SECTION 009113 – ADDENDUM ONE

- A. Project Name: 22034.02 Meridian High School Additions, Renovations and Ballfield Rebid
- B. Owner: Meridian Public School District, 1019 25th Avenue, Meridian, MS 38391
- C. Architect: Dale | Bailey, an Association, One Jackson Place, Suite 250, 188 East Capitol Street, Jackson, MS 39201-2100
- D. Architect Project Number: 22034.02
- E. Date of Addendum One: 5 January 2024

1.4 REVISIONS TO DRAWINGS

C-600

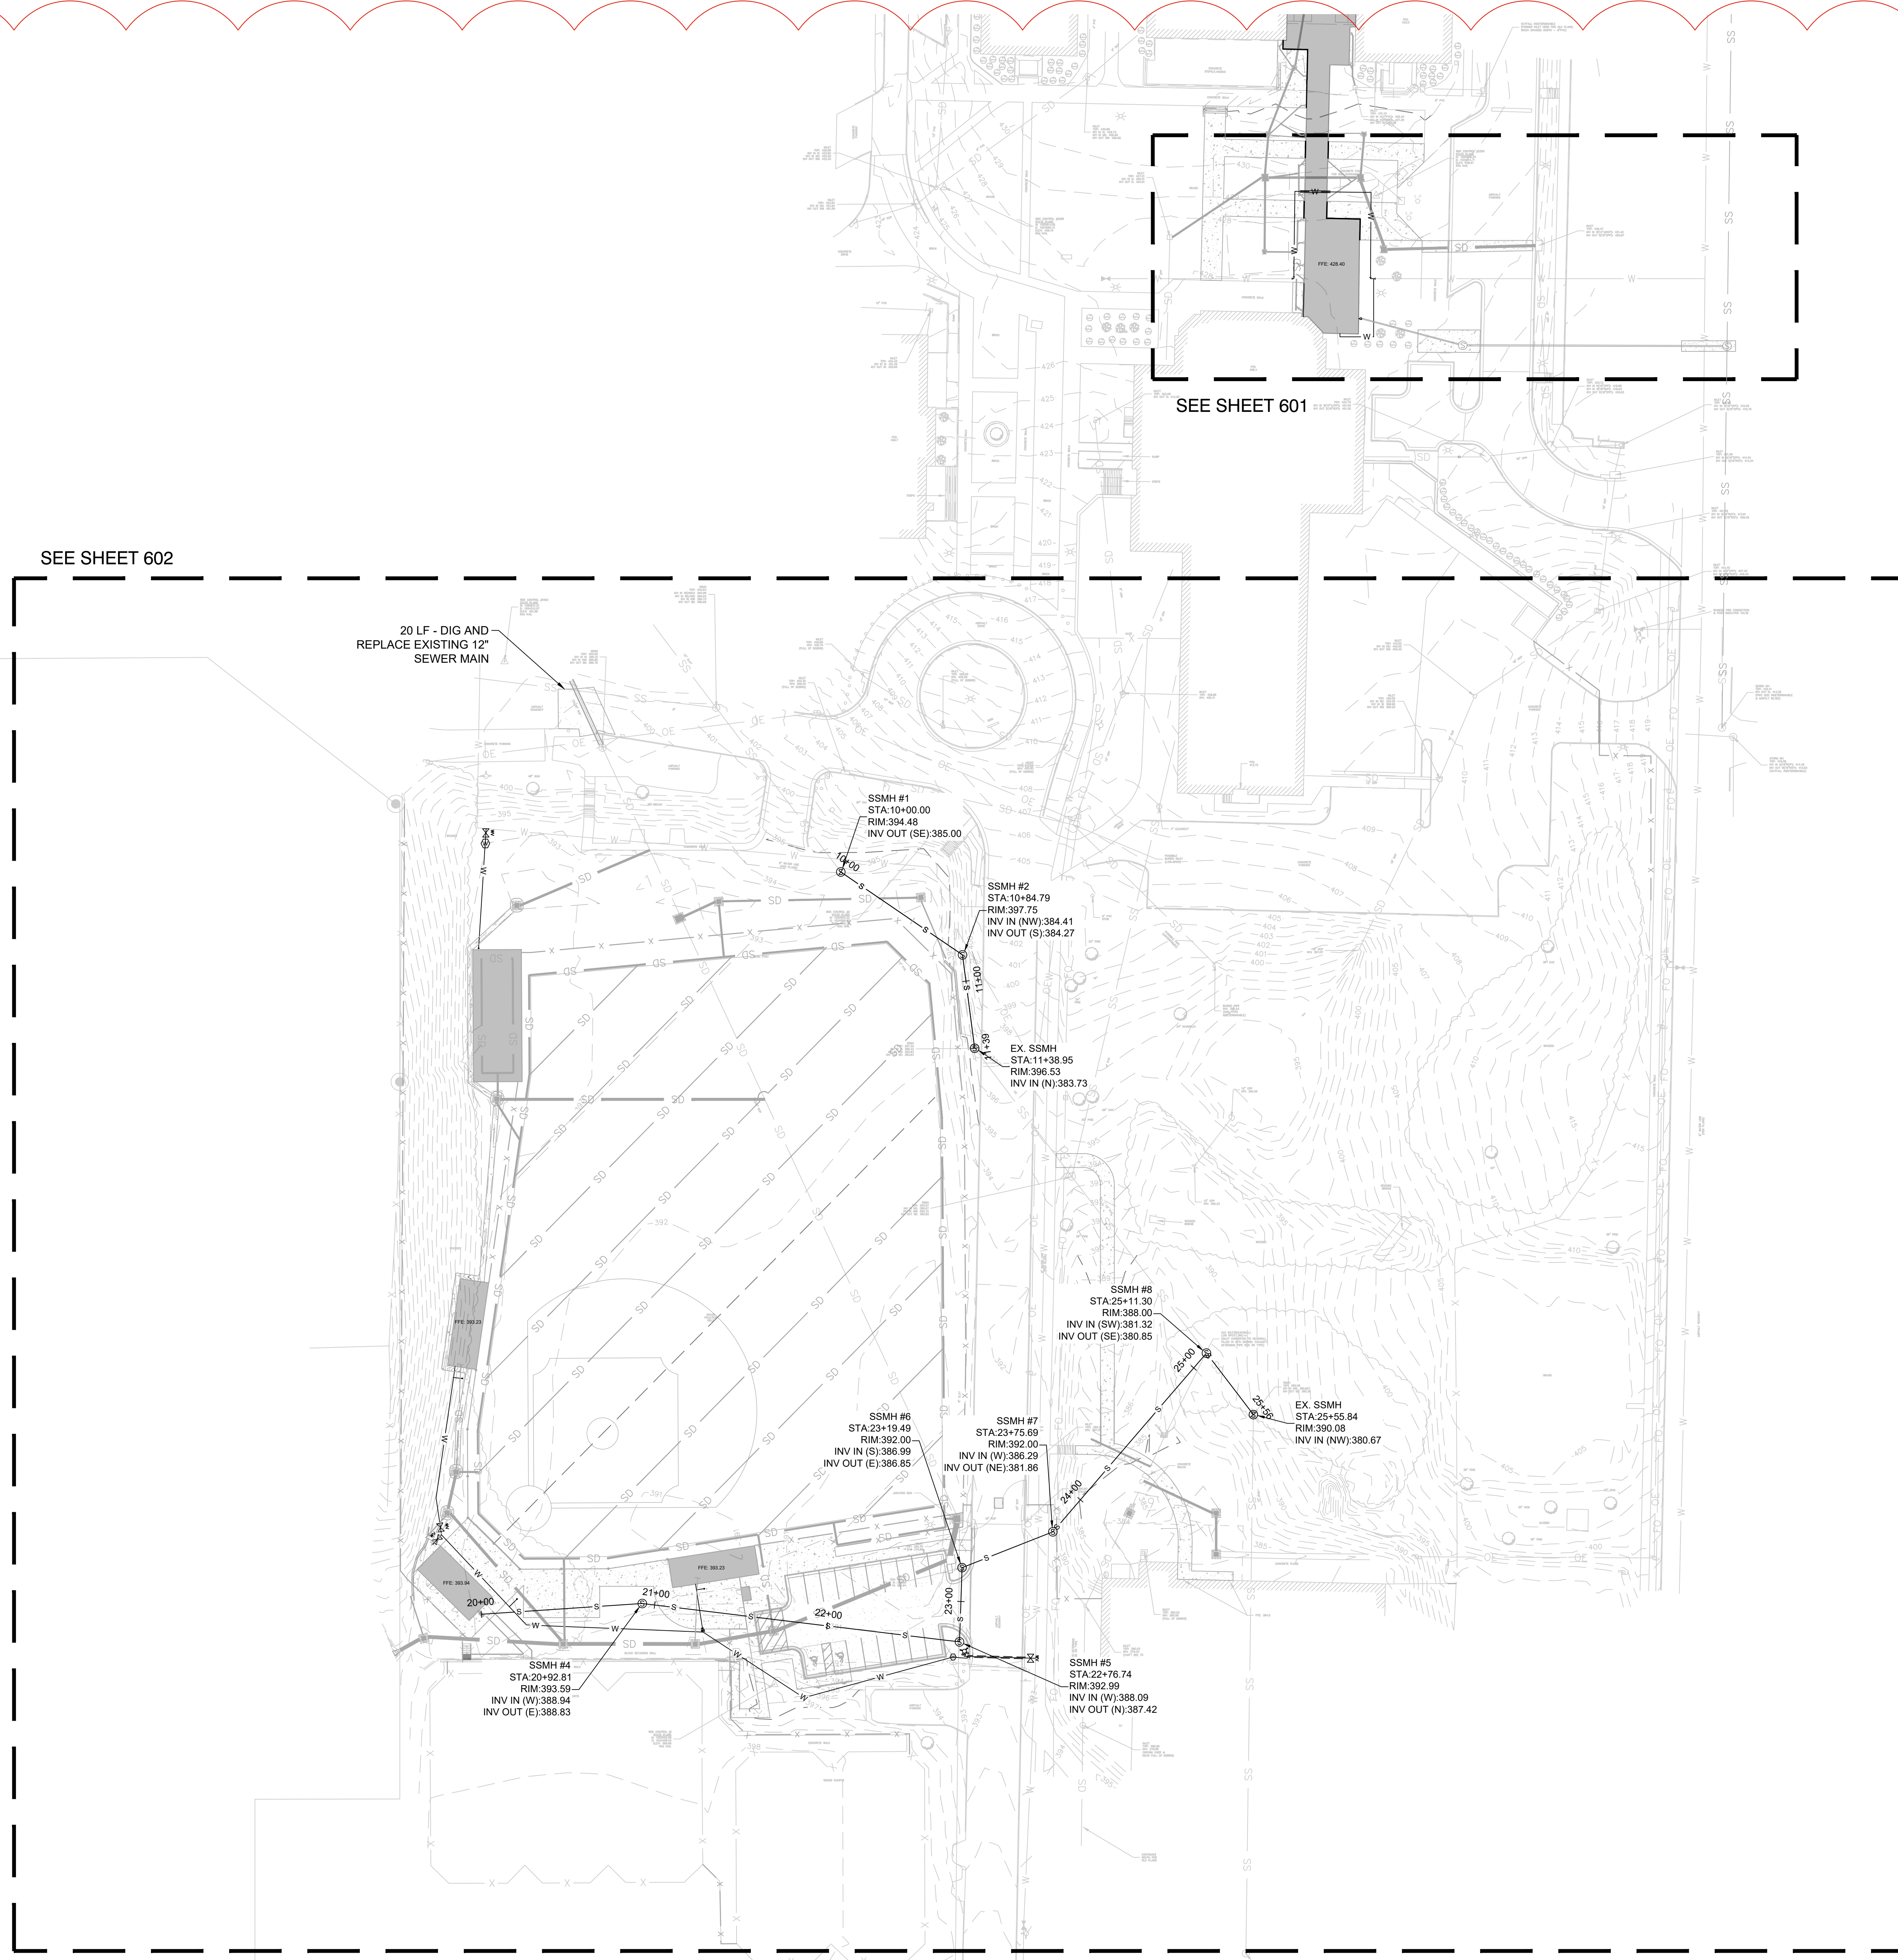
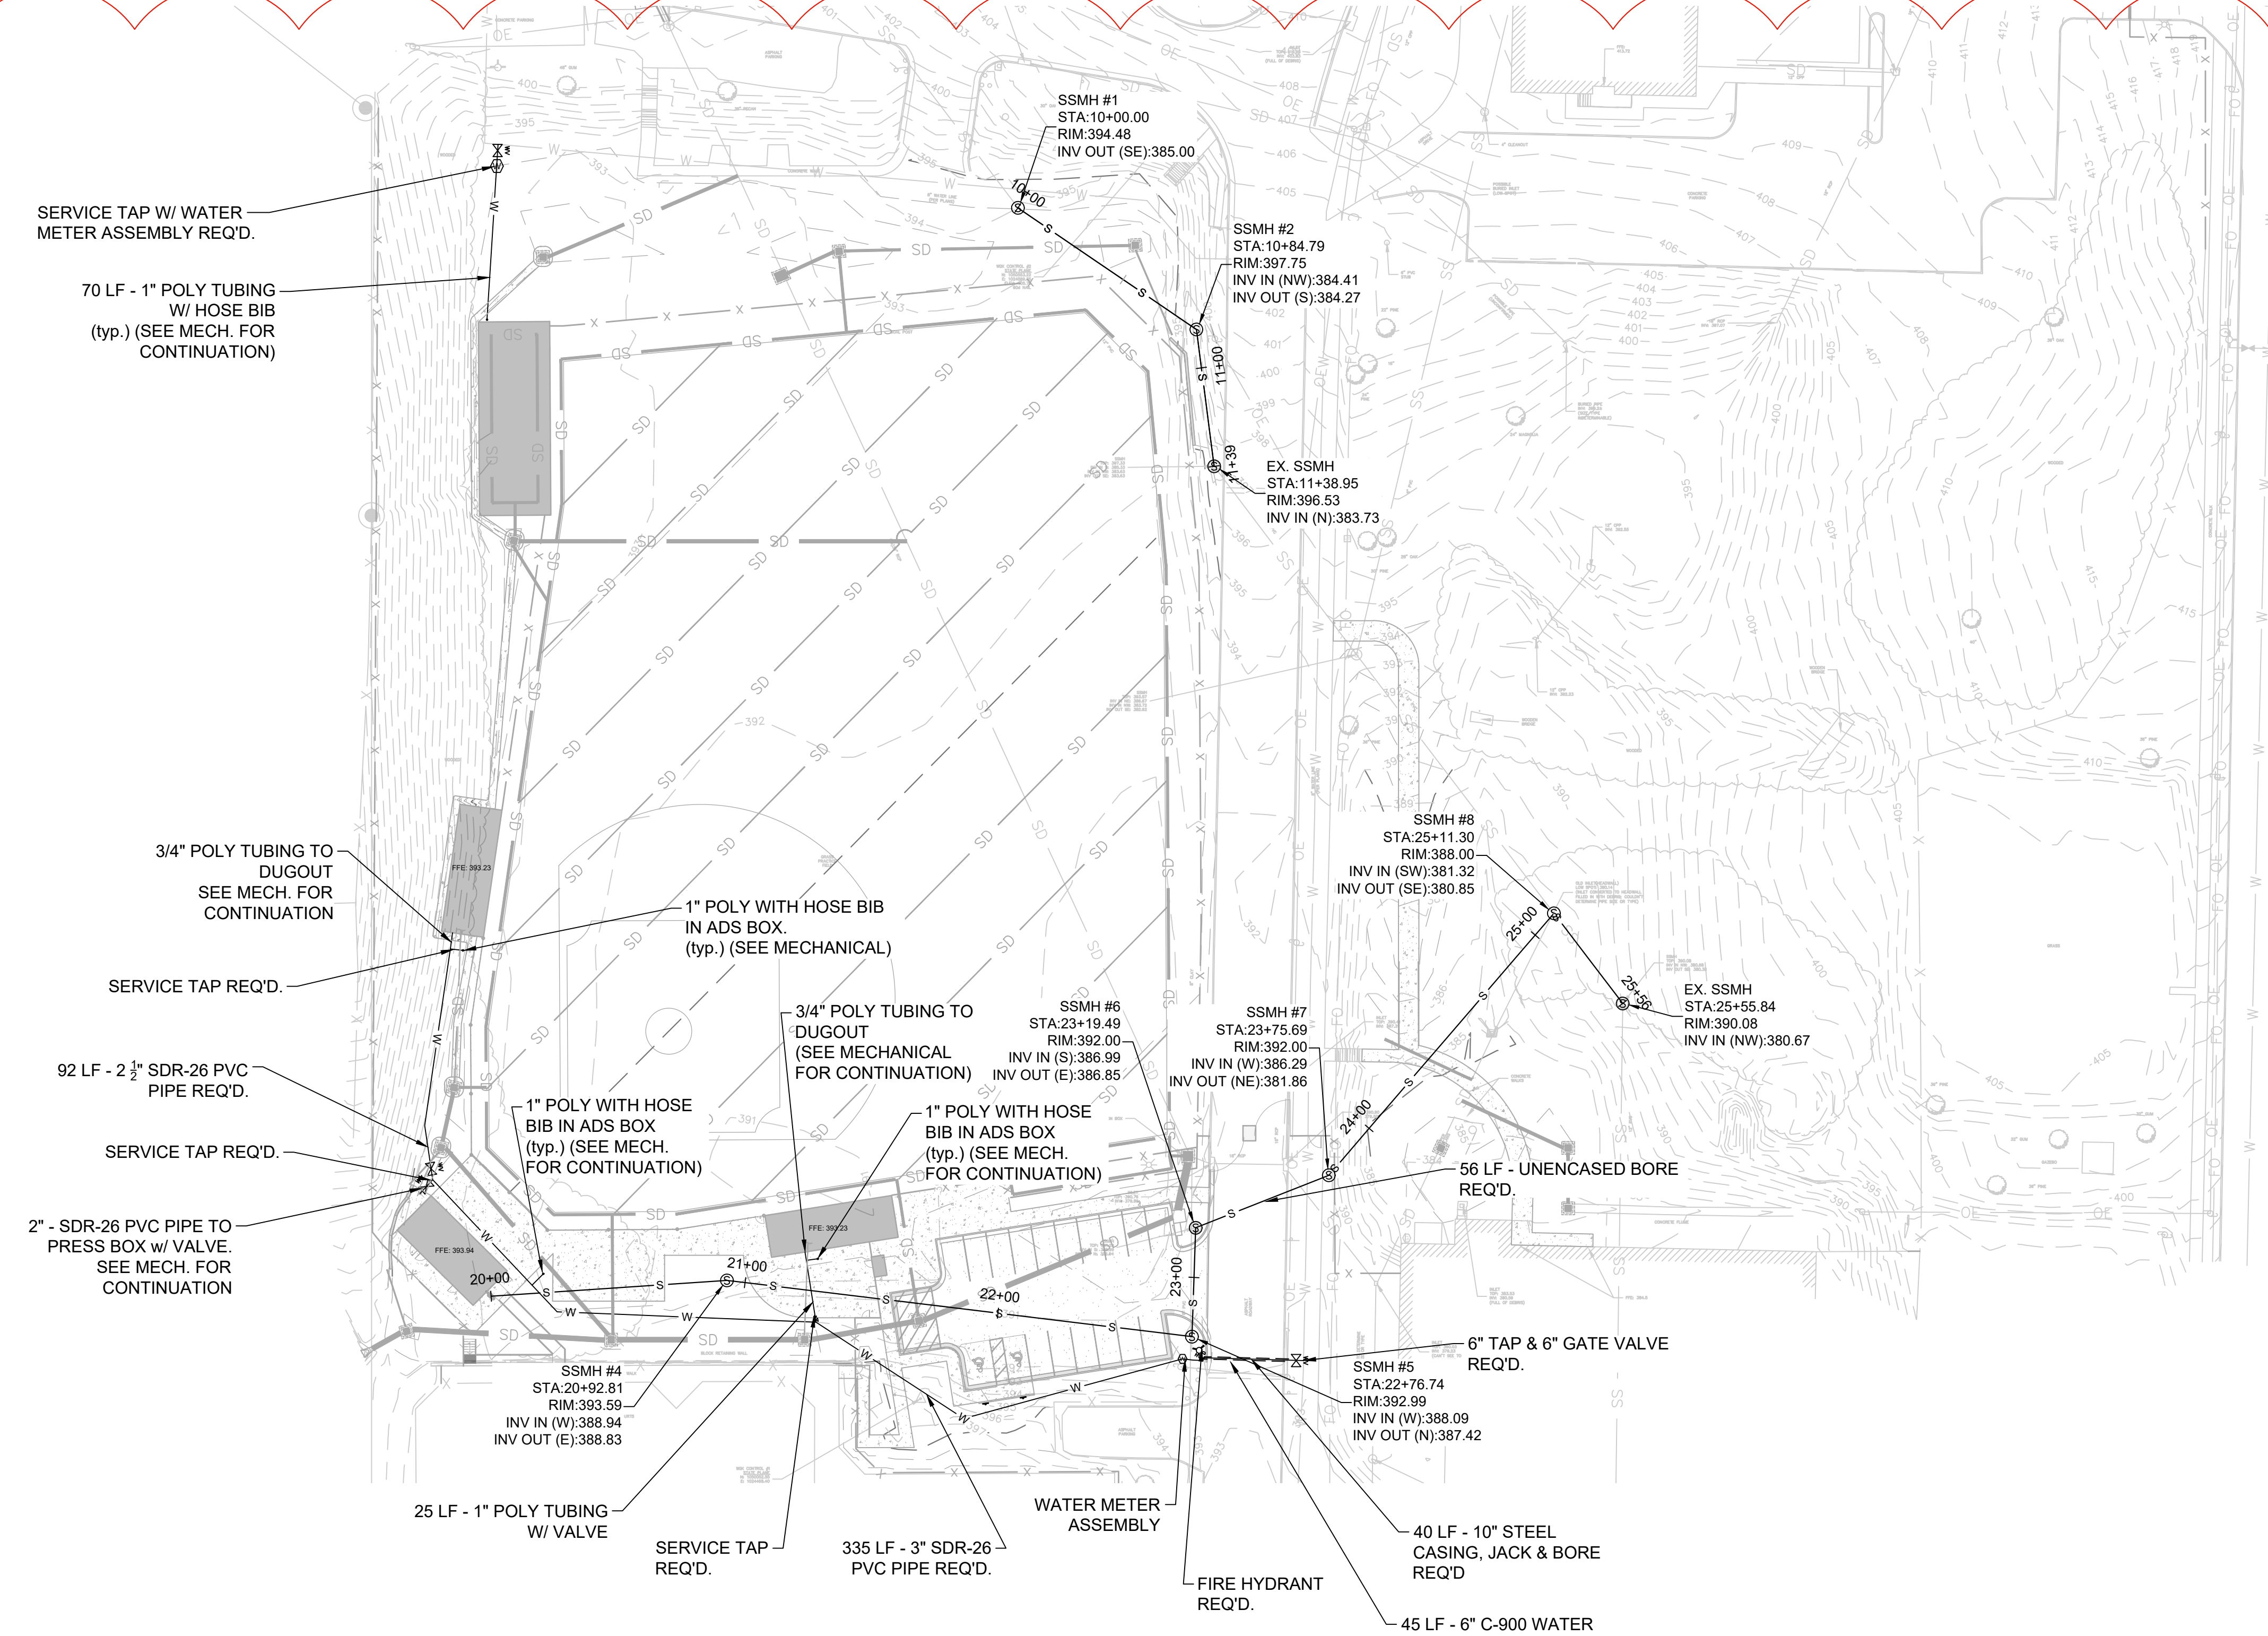
- P. Sheet C-600 (Revised). Updated to reflect water/sewer work at baseball area
- Q. Sheet C-602 (New). Added to reflect water/sewer work at baseball area

C-800

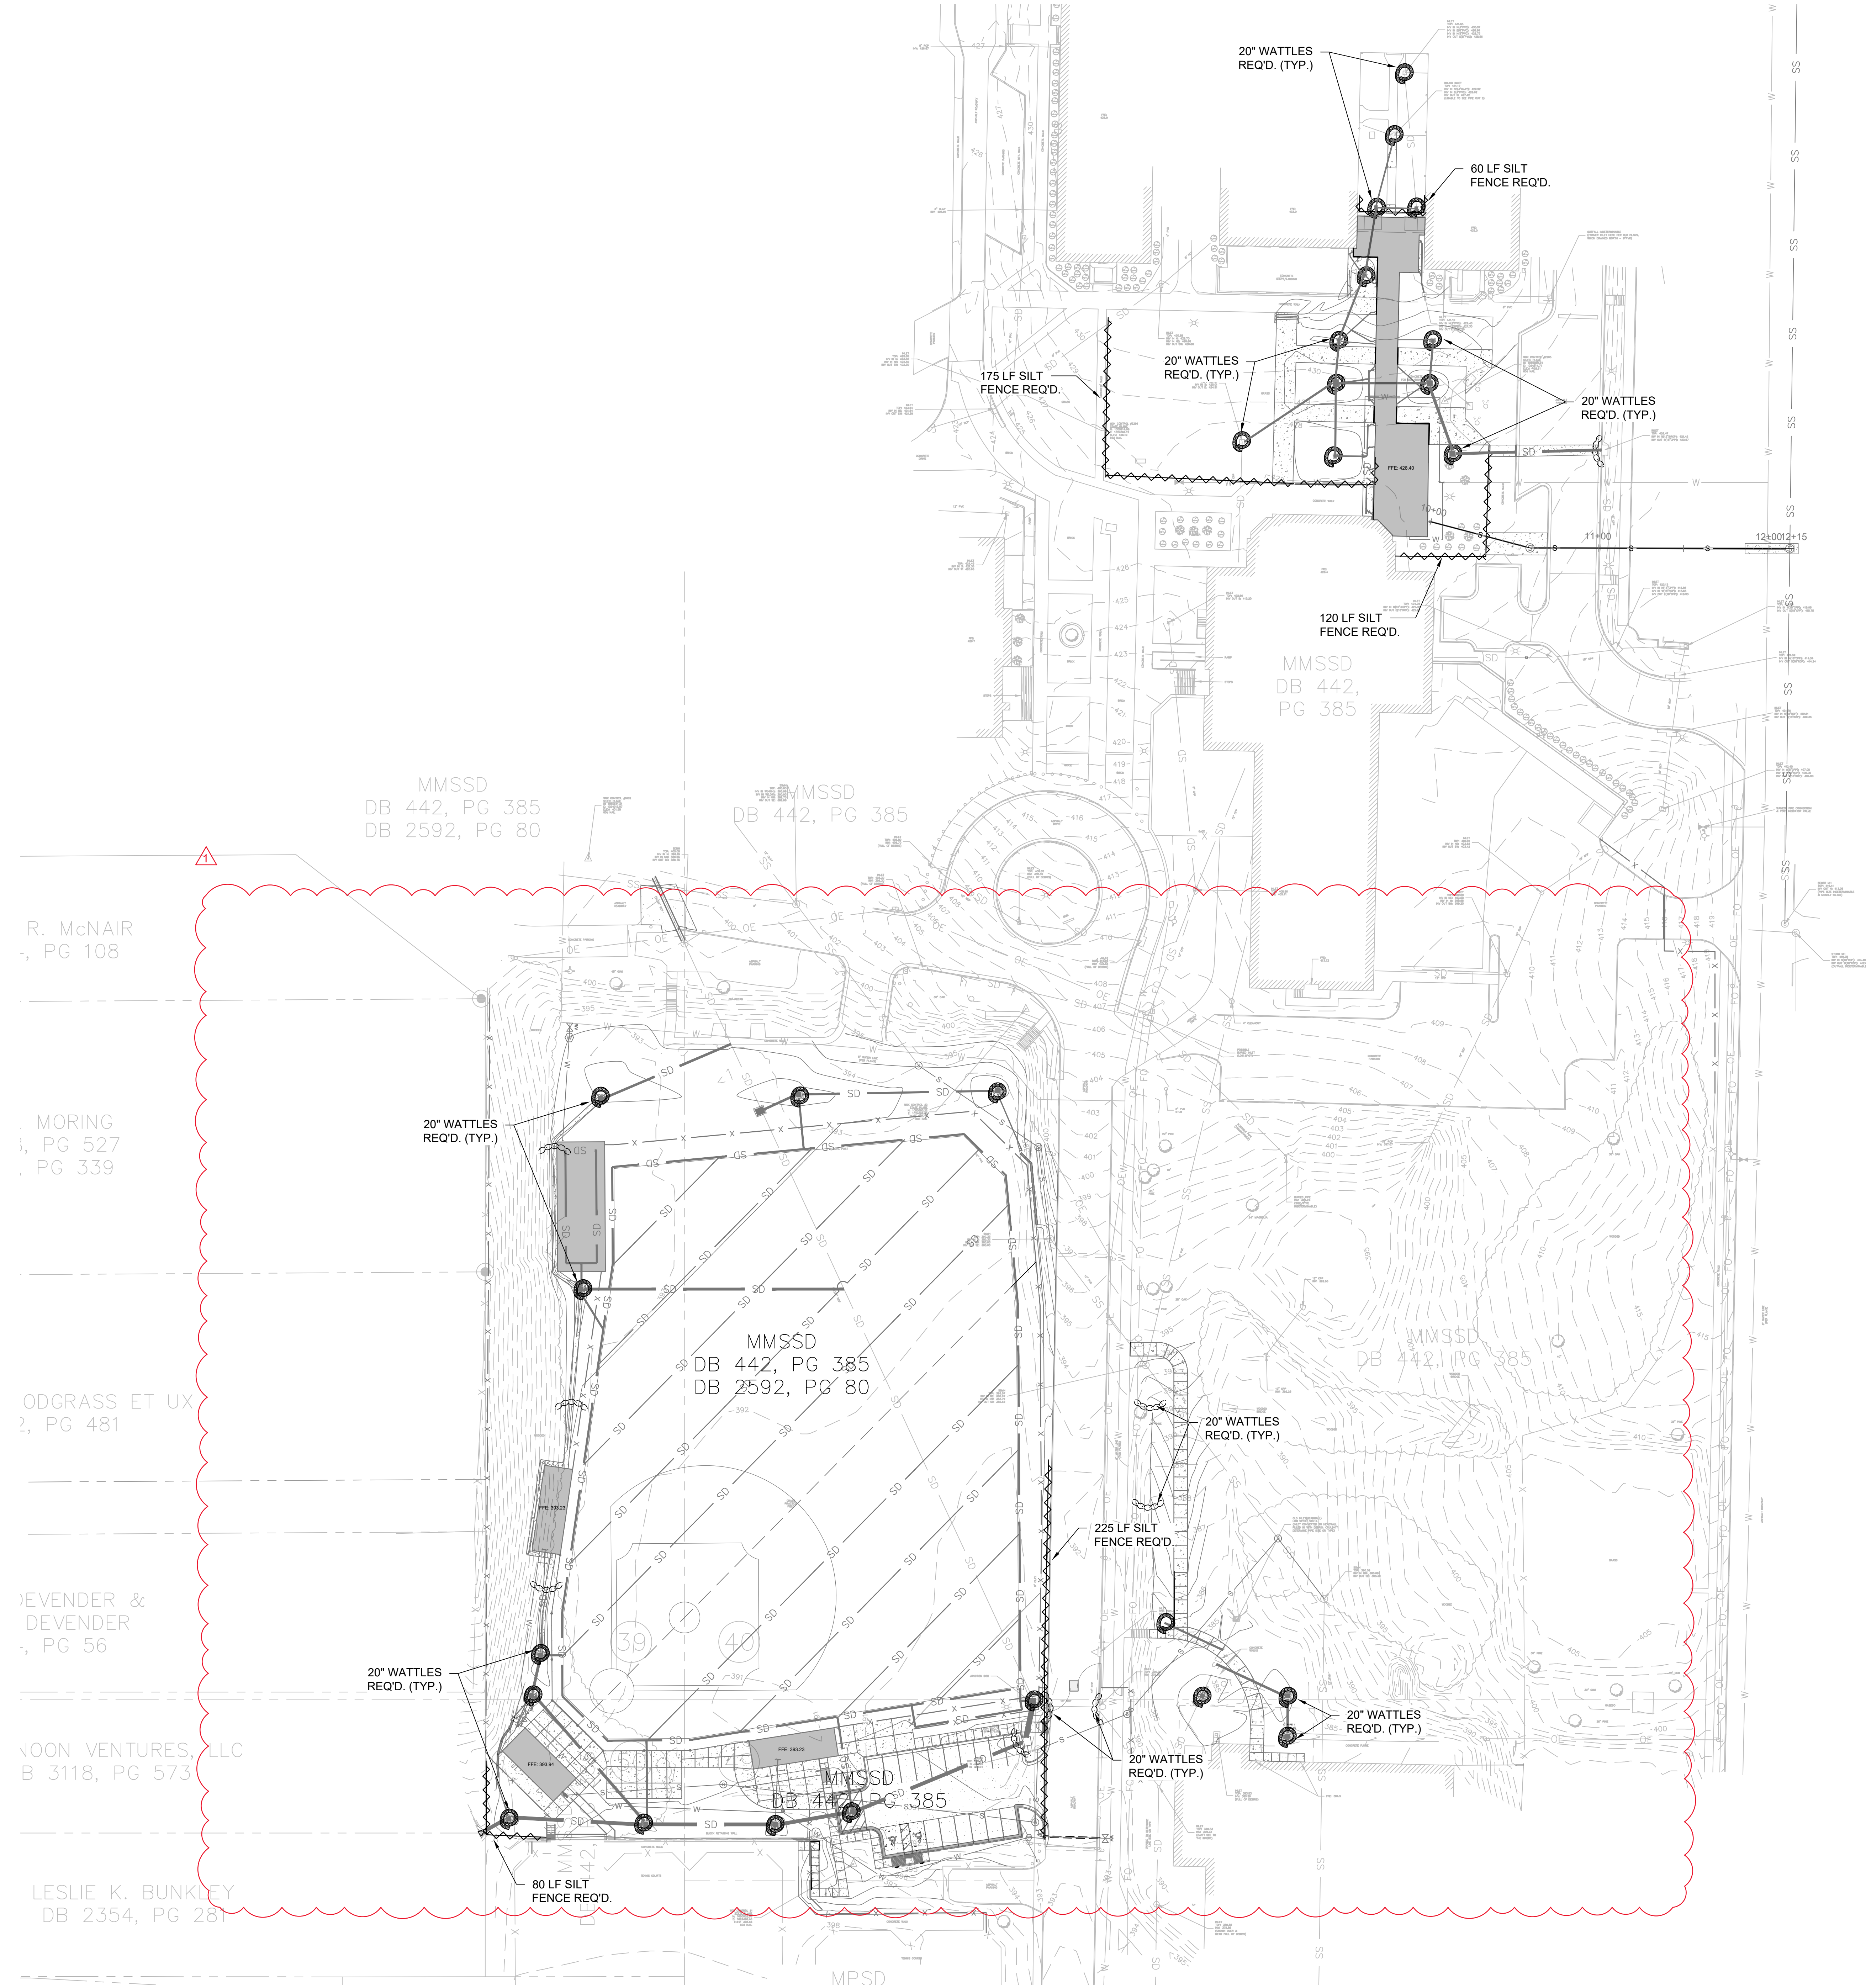
- S. Sheet C-800 (Revised). Updated to reflect additional erosion control measures.
- T. Sheet E-004a (Revised). Added power for the gate at the east entrance.
